City of Albuquerque

RE: REVISED DRAINAGE PLAN FOR PLAZA NATIONAL BANK
(G-20/D30) REVISION DATE OF FEBRUARY 6, 1990

DRAINAGE PLAN
TRACT 1A, BLOCK 22, THOMAS ADDITION
ALBUQUERQUE, N.M.
ZONE MAP G-20 BENCHMARK "13-F20" ELEV.=5502.37
FLOOD MAP 24 SOIL TYPE "B"
FILE No. G20/D30 APPROVED 2-1-90

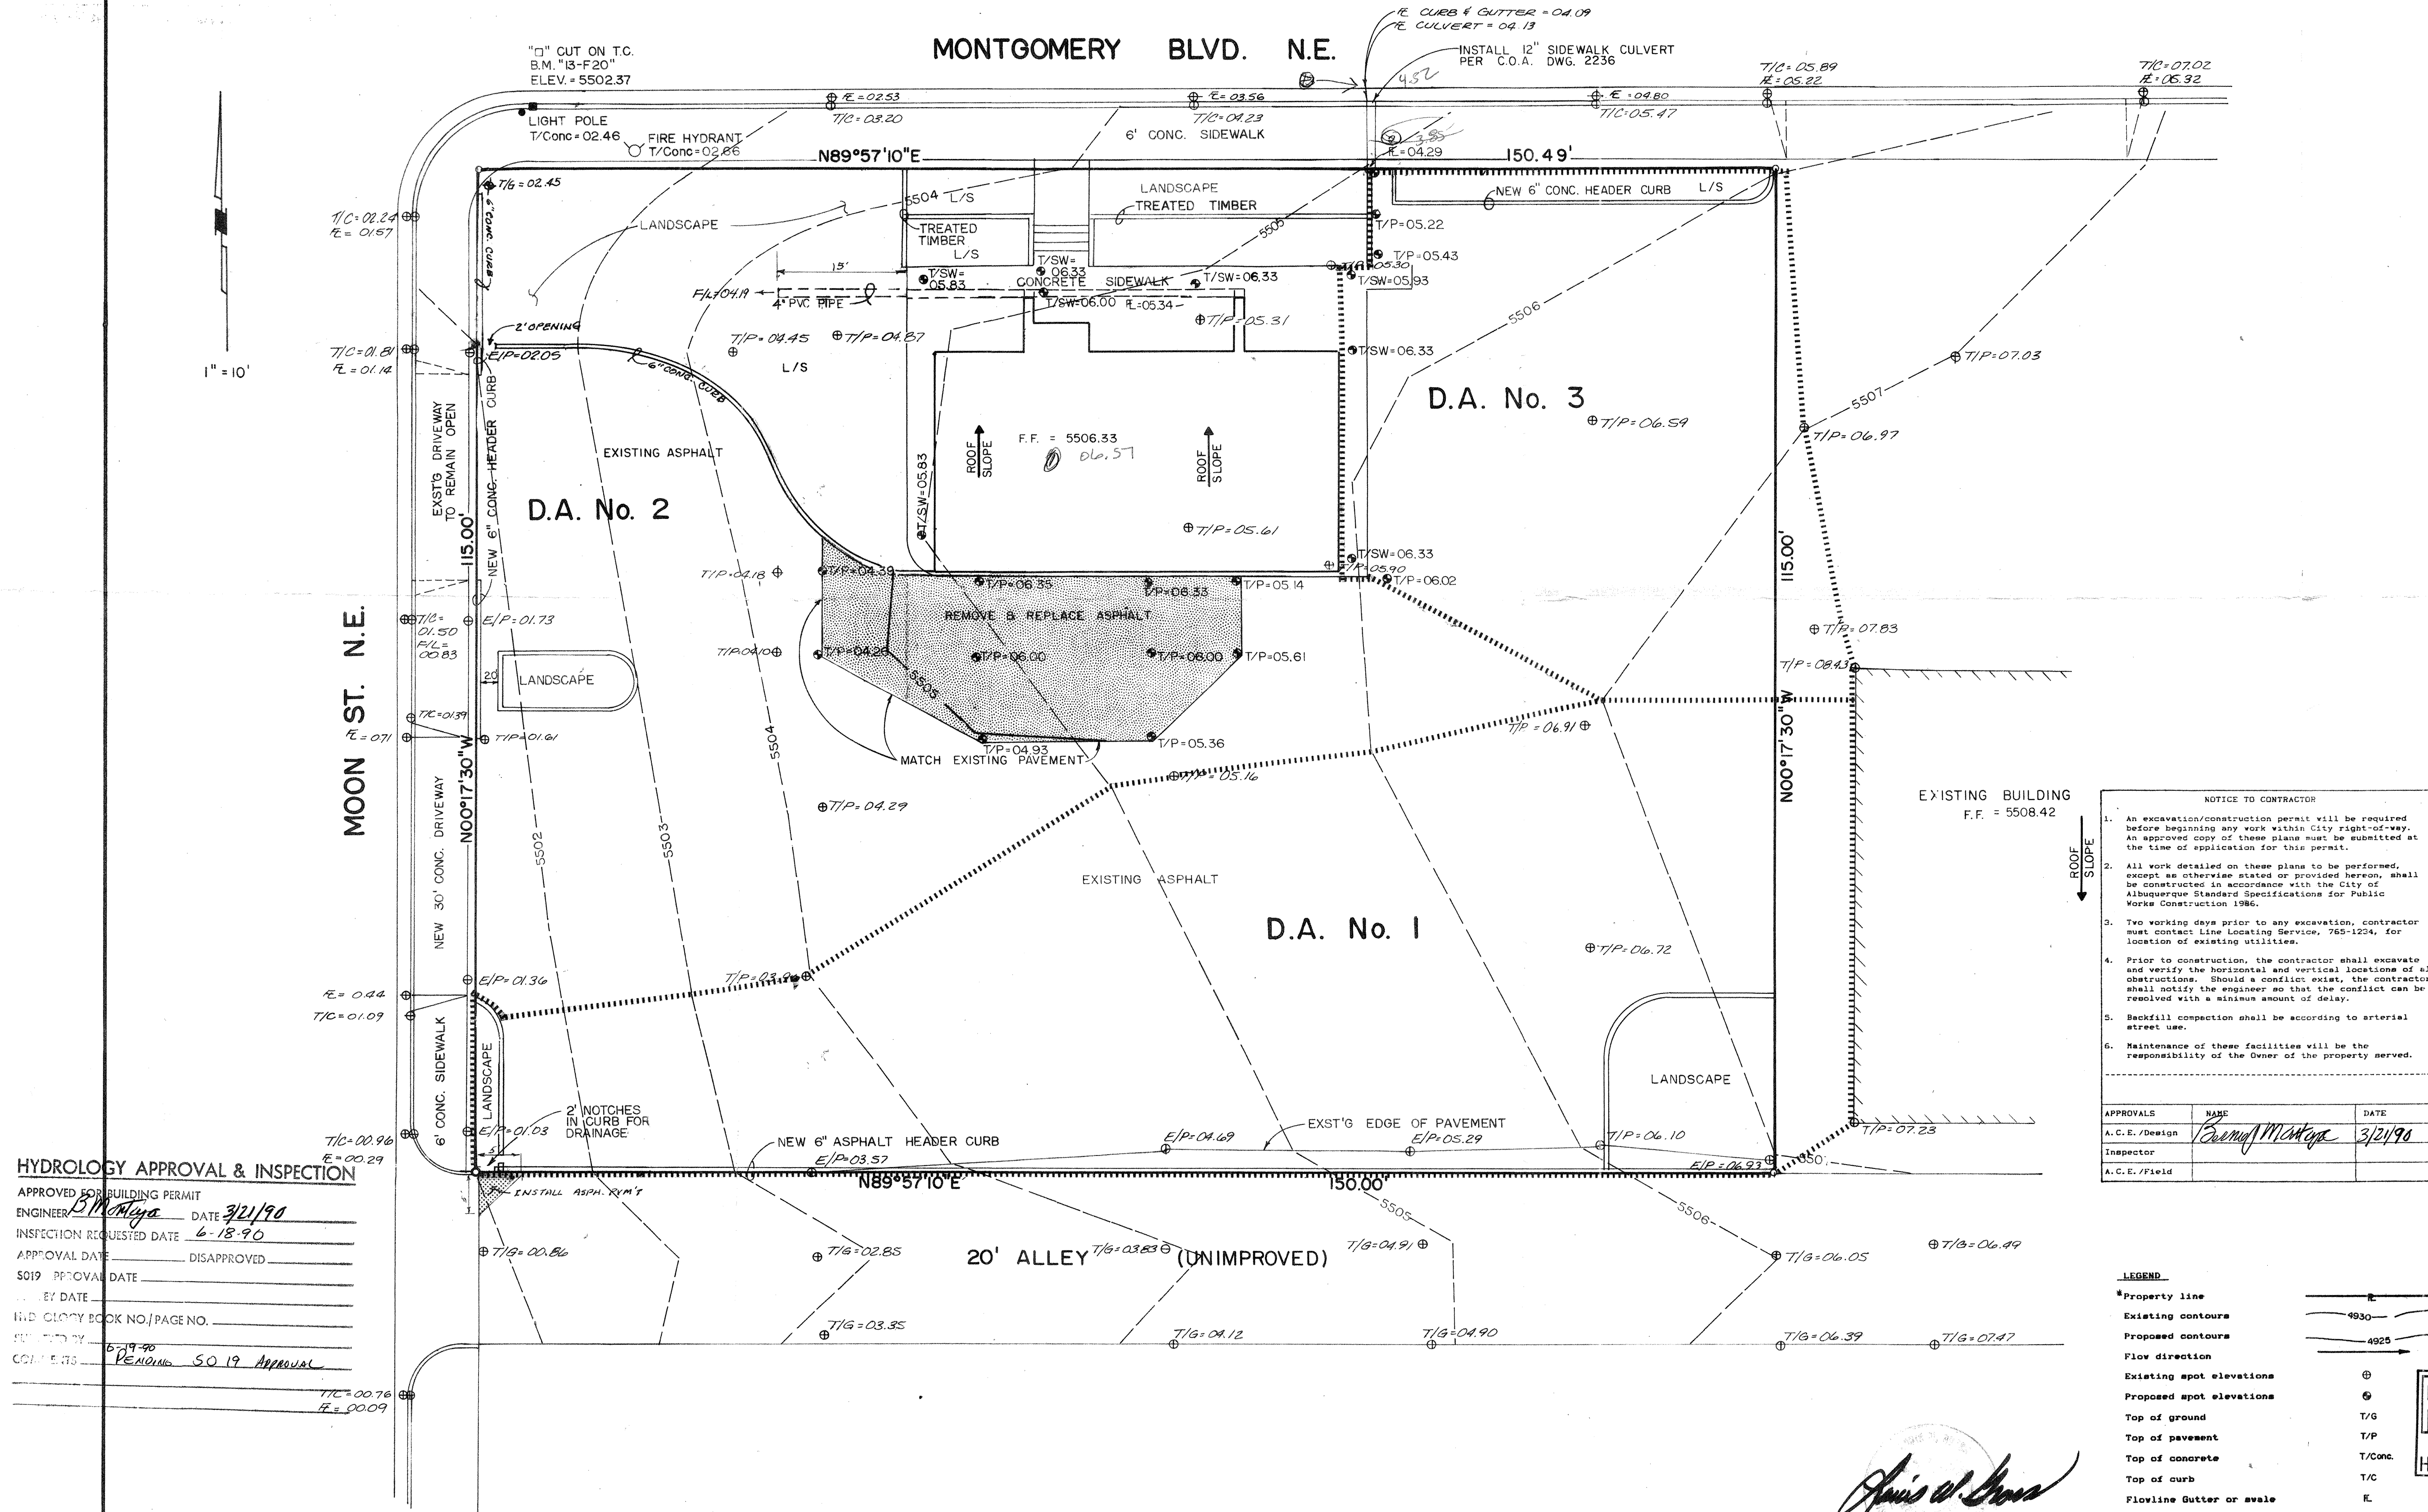
Based on the information provided on your resubmittal of February 7, 1990, the revisions as indicated are acceptable for Building Permit.

Your client should be advised that developed runoff will not be allowed to enter the unimproved alley. If for some reason the proposed asphalt curb is damaged, it will be their responsibility to assure that it is repaired and no runoff is allowed to enter the alley.
